Attachment 1 - PLN17/1059-05 - 33 Peel Street Collingwood - subject land

33 PEEL STREET COLLINGWOOD

Internal departments

Attachment 3 - PLN17/1059-05 - 33 Peel Street Collingwood - sketch plan showing splay

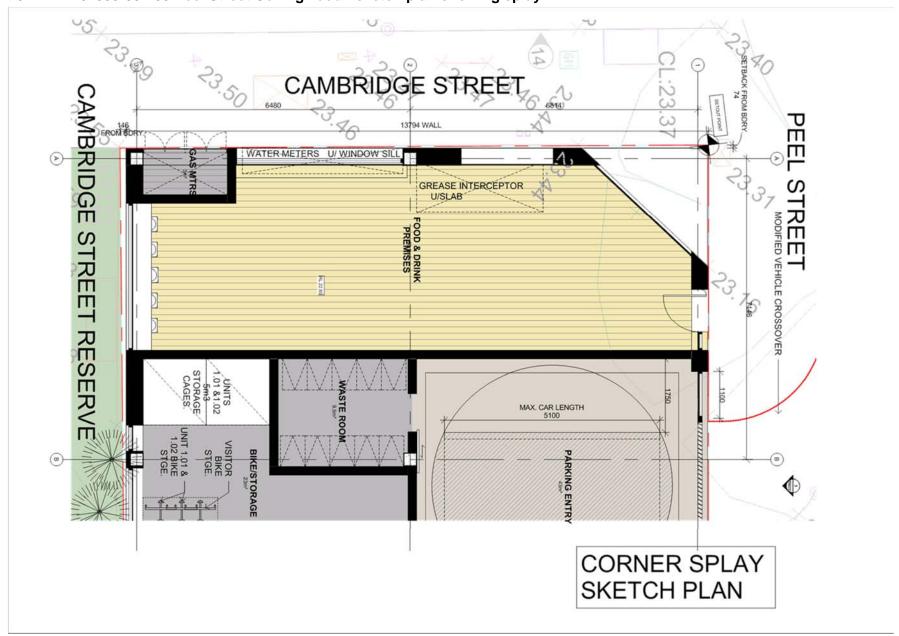
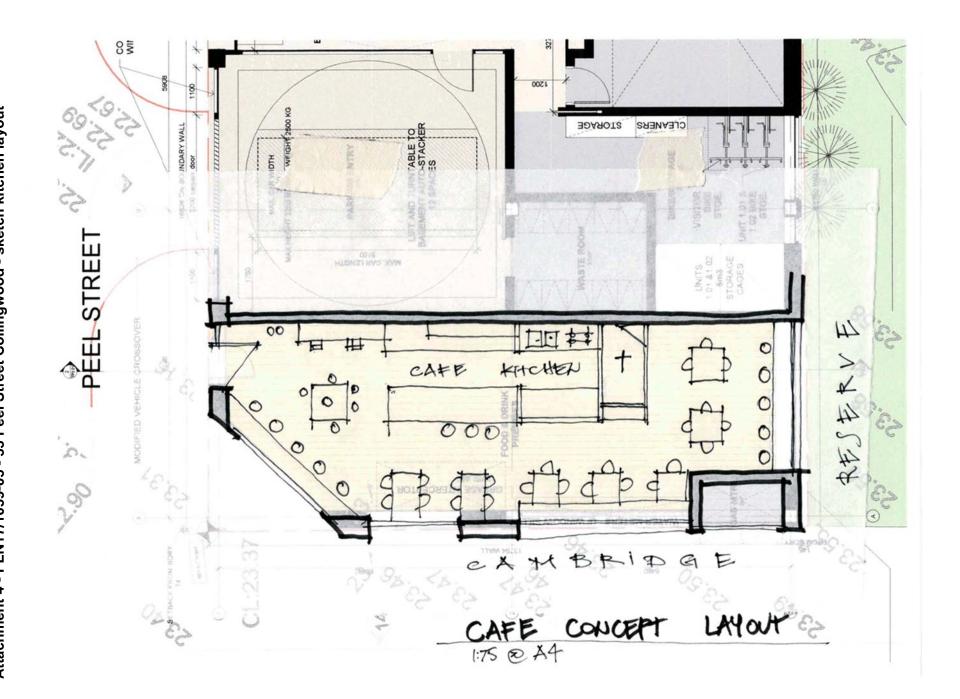
The plans are fine and generally in accordance with what Fiona sketched up. The only comments I would make are that it may be preferable to have the bbq central between the two picnic settings, but this can be resolved during detailed design.

Corner Splay

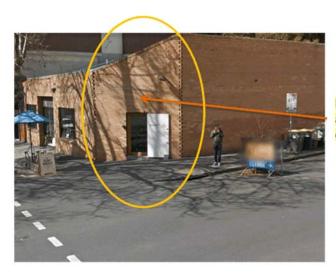
The proposed development plans show the corner splay at the north western corner of the property to be occupied by the development.

The corner splay at ground level must remain intact. Regardless of whether the splay is in private ownership, it is deemed to be part of a Public Highway by virtue of its previous and existing use by the public (i.e. – pedestrians). The splay must remain in asphalt (consistent with the surrounding footpaths) and must not be reduced in size. The applicant must depict the splay on the proposed Ground Floor Plan. The splay can be occupied above ground level (i.e. first floor and upwards).

Existing splay to remain intact and not to be occupied by the development

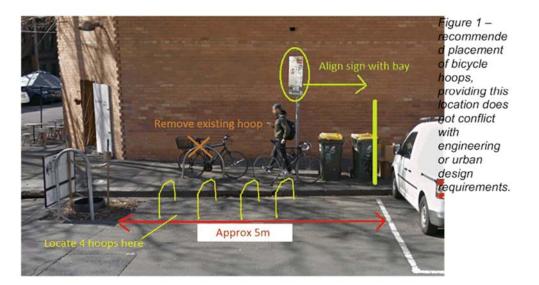
1 space is noted as a visitor bicycle parking space. The provision of the visitor spaces is inadequate for the following reasons:

- Whilst 1 spaces meets the statutory requirement: best-practice requires a rate of 0.25 visitor spaces to each dwelling¹, requiring 2 spaces for the 9 dwellings.
- A car parking reduction of 8 spaces is sought, including for four visitor spaces. Further, Council already notes a shortfall of visitor bicycle parking within the immediate vicinity of the development, and the proposed development is likely to contribute further to this shortfall.
- It is usually preferred that all visitor spaces are provided as horizontal rails outside of secure facilities for ease of access and use.

Given all of the above, it is recommended the applicant provide a number of bicycle hoops at the Cambridge Street frontage. There appears to be space to provide at least 4 bicycle hoops (8 bicycle spaces) within the roadway between the existing street tree and car parking bays (Figure 1). This has been discussed with Council's Engineering Unit who have offered general support for the concept.

- The provision of at least 4 bicycle hoops at the Cambridge Street frontage, within the roadway between the existing street tree and angled parking bay.
- 2. Removal of the existing bicycle hoop within the Cambridge Street footpath.
- Relocation of the existing parking restriction sign at the Cambridge Street frontage to align with the parking bay.
